Response to "1st batch of Qualification Lots"

Response Clemens Quinones/Cebu/Fairchild 06/07 04:09 PM	Subject:	>Look Ahead Qualification Assembly Results
	Response to:	1st batch of Qualification Lots
	Category:	Wireless SO-8 Pkg Dev't (FLIP-CLIP Technology, Matrix Mold Thru Gate Design)
	Keywords:	Wireless SO-8 Matrix Package Development

To: patrick@sharpmax.com.hk, Mina Alvarez <mina@pdii.com>
 cc: Clemens Quinones/Cebu/Fairchild@Fairchild (bcc: Ma Cristina B Estacio/Cebu/Fairchild)
 Subject: URGENT: SDI to Correct as per drawing

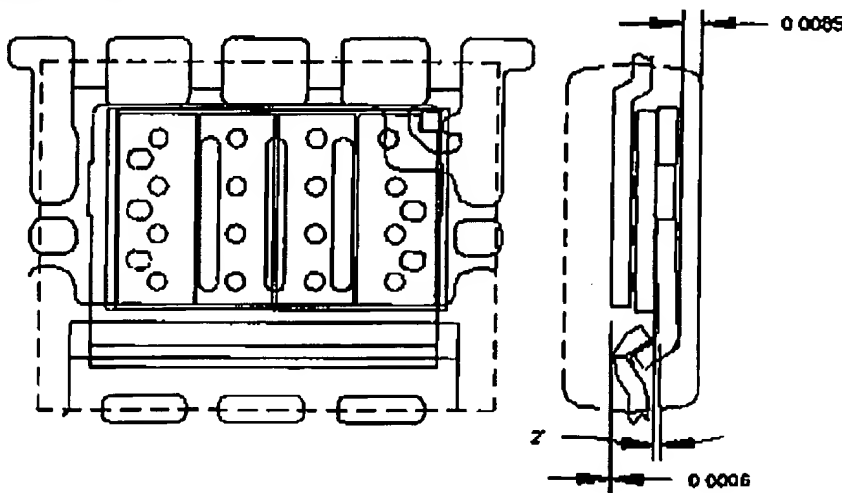
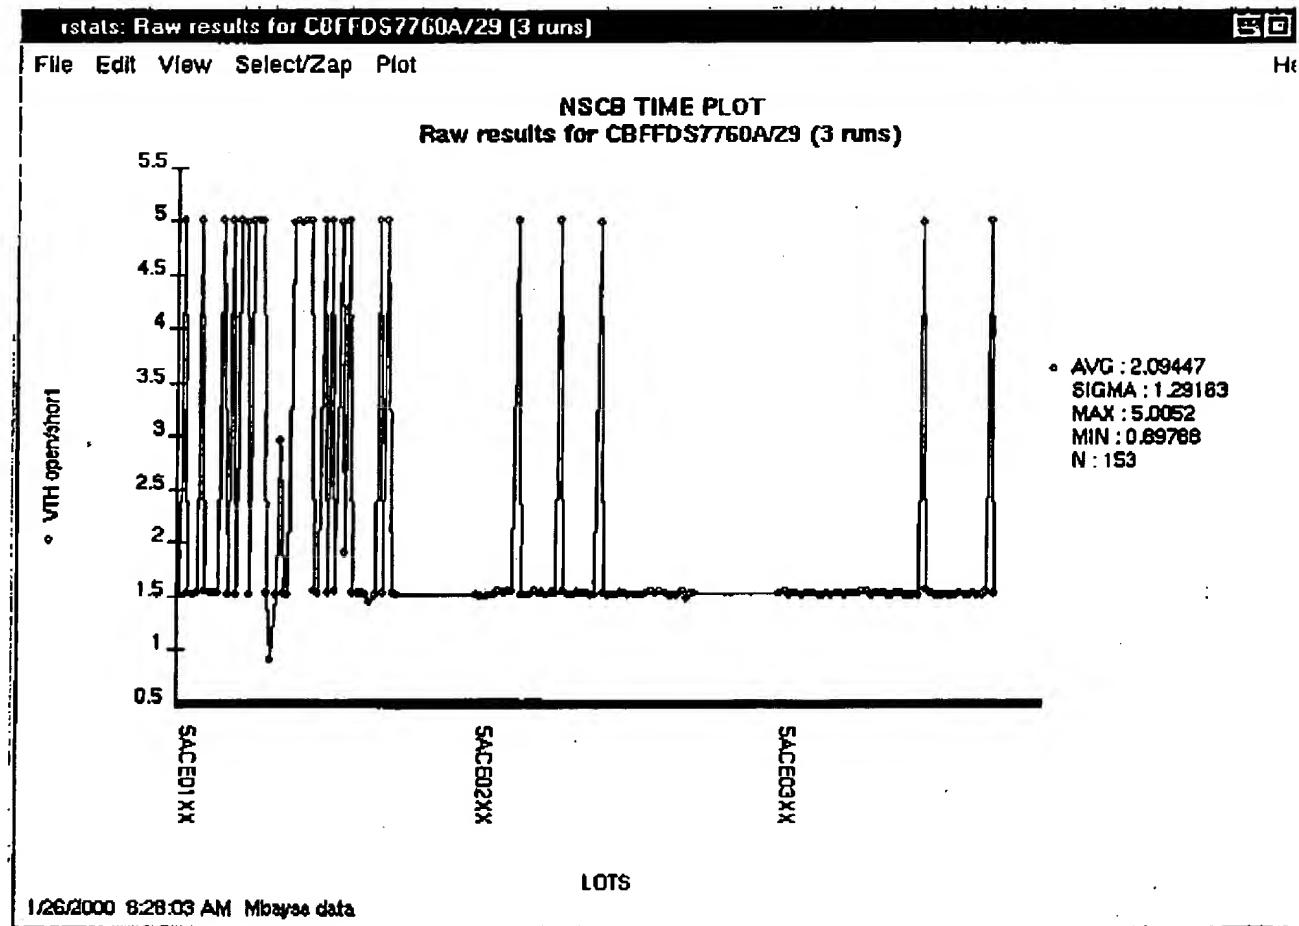
We have made some actual crosssections on the units and the actual parts do not meet as per dimensional requirement. Pls discuss this with your Engg guys so we can correct on the 200K order. Pls confirm ASAP.

Attached is the build diagram of the frame design with the die. These are the dimensional comparison made:

Drawing req't: Actual measurement:

Clip angle 2 degrees 5 - 6 degrees

Level difference 0.6 mil 2.6 - 2.8 mils

bet. v-groove and pad.

If we meet dimensions as per dwg, clearance from the clip to the mold pkg is 8.5 mils, currently this is very small as per actual cross-sections.

flipclip.jpg topframe.jpg

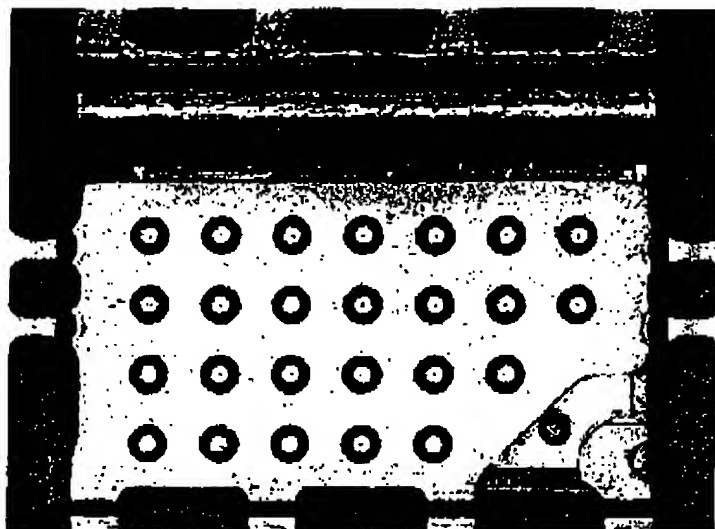
We have inspected the actual units and more or less the attached drawing represents how the units look like (actual measurements can only be available after we can sample some units for crosssection.) The concern is on the amount of paste dispensed on the die backside during clip attach. This was highlighted during the sample builds that we have done when I was there but since we did not have the luxury to further optimize the amount of paste dispensed both on the die back and v-groove, the suggestion based on the informal discussions that we had was to redesign the dispense tool. Pls confirm if the dispense tool with the optimum design will be available upon shipment of the clipbender.

I am also sending a picture of one unit from the actual build.
